LIGO E-TRAVELER

E-Traveler DCC Number & Revision	Schematic DCC Number & Revision	Board Title	Board Serial Number
D080149-00-C	D020241	ISS Intensity Stabilization Servo	111
PCB Revision	Cognizant Design Engineer (COG)	E-Traveler Originator & Institution	Date
Rev D		Stefan Ballmer, Caltech	3/27/2008

E-Traveler DCC Number & Revision	Schematic DCC Number & Revision	Board Title	Board Serial Number
D080149-00-C	D980369-00-C	ISS photo diode	
PCB Revision	Cognizant Design Engineer (COG)	E-Traveler Originator & Institution	Date
00		Stefan Ballmer, Caltech	3/27/2008

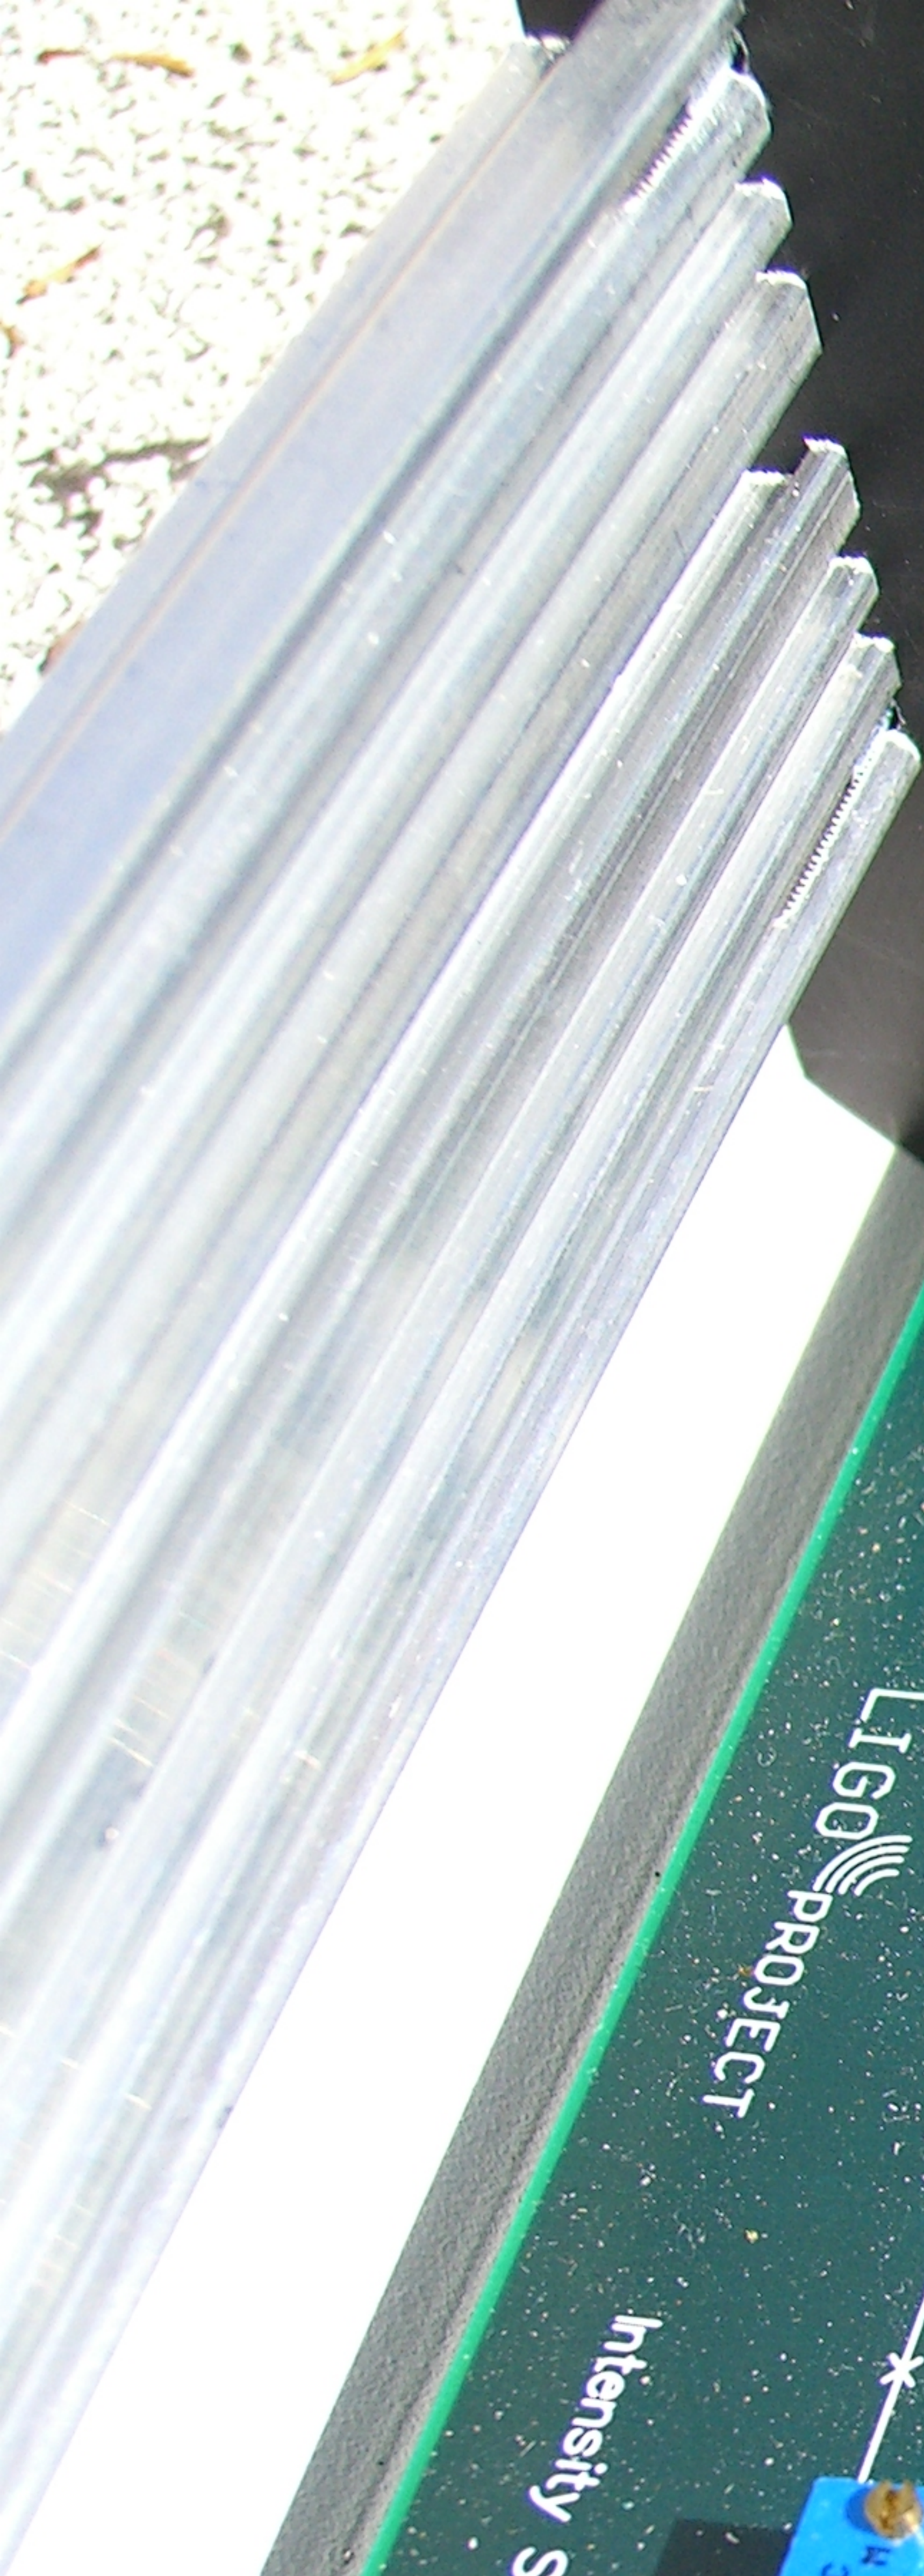
Performed By:	Date
- AD829 was mounted the wrong way	Stefan Ballmer	3/27/2008

Performed By:	Date
- Add C=10uF in paralell to C4 (provide quiet +5V) - Connect DSUB pins 5,6,7,8, and (most impartantly) pin 9 to ground patch	Stefan Ballmer	3/27/2008

Intensity Stabilization Servo

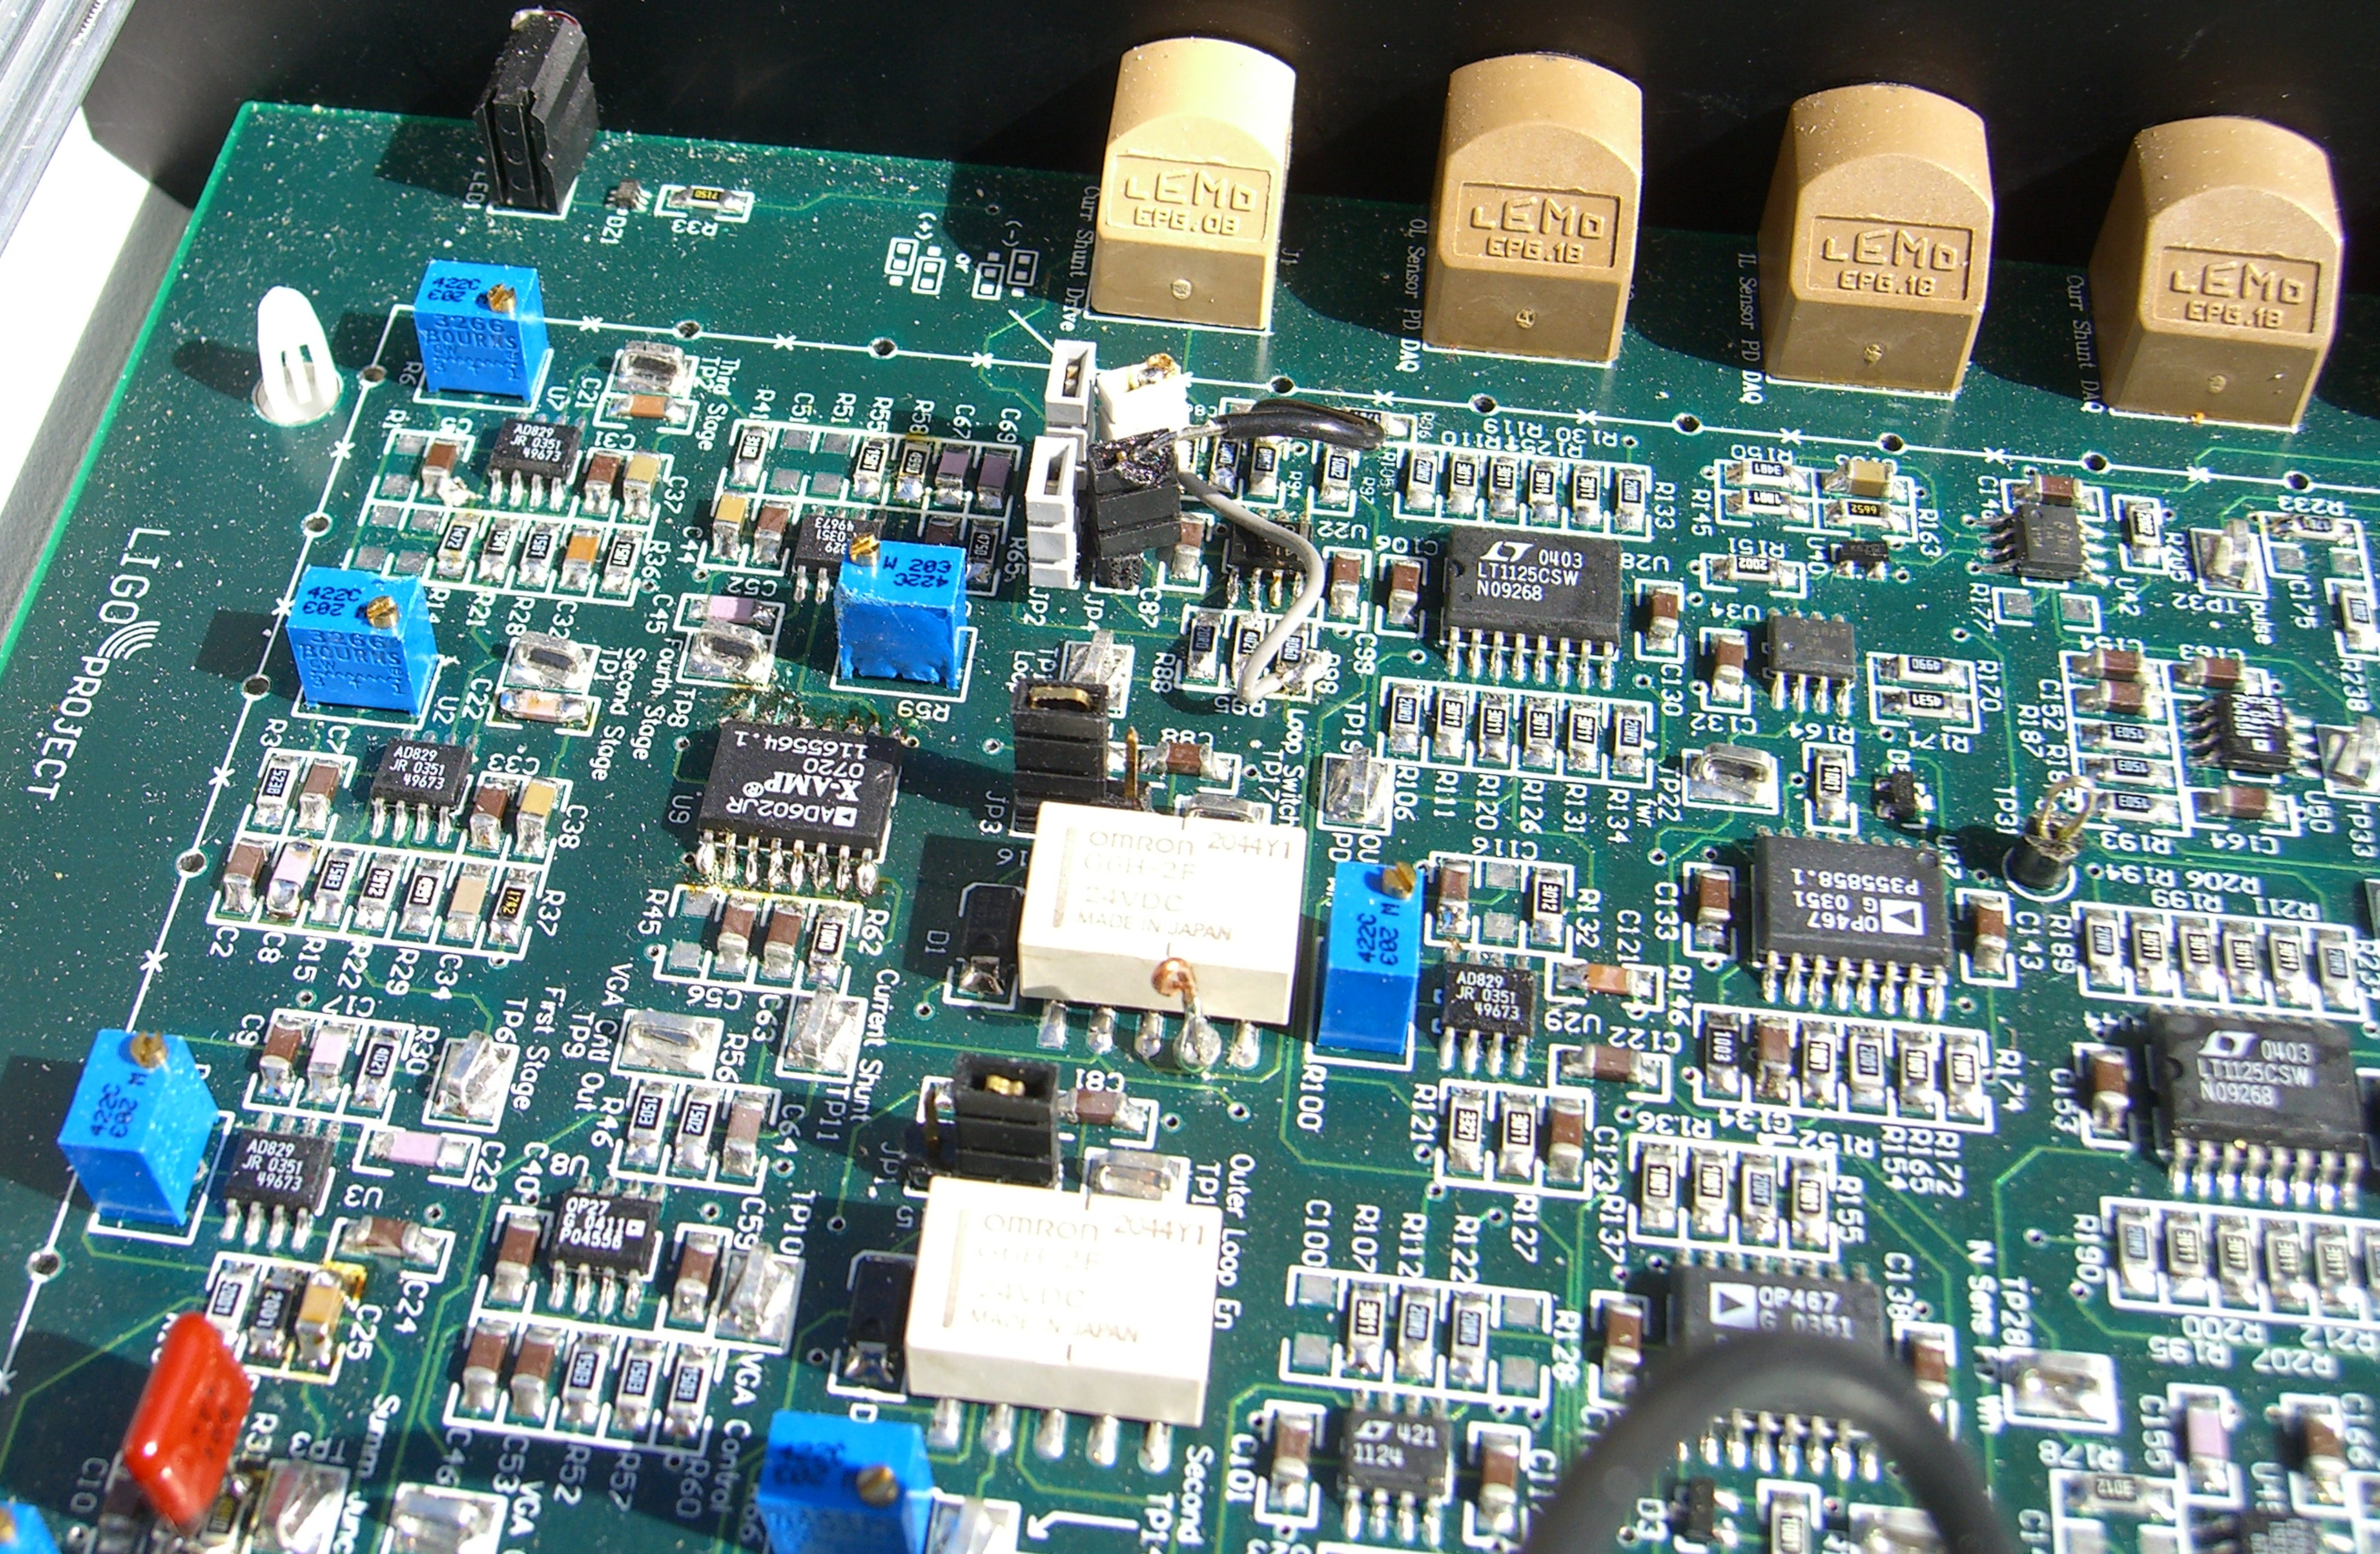
- Replace "Belden 9232 Low Noise Coax" with something that doesn't short out.
- Many AD829's were oscillating and had no Ccomp. Produced x-talk even if outside signal path. Added Ccomp =15pf (data sheet).

- U6, U54, U20, U64 change to THS4131
- R31: add C=150nF in parallel (2.1kHz pole)
- by-pass U22: - wire from R94 ground side to jumper (JP2 or JP4) pin for connector (J1) minus
 - wire from R98 loop switch side to jumper (JP2 or JP4) pin for connector (J1) plus
(Note: We need single-ended drive. This way U9A drives the cable - not ideal but it works.)
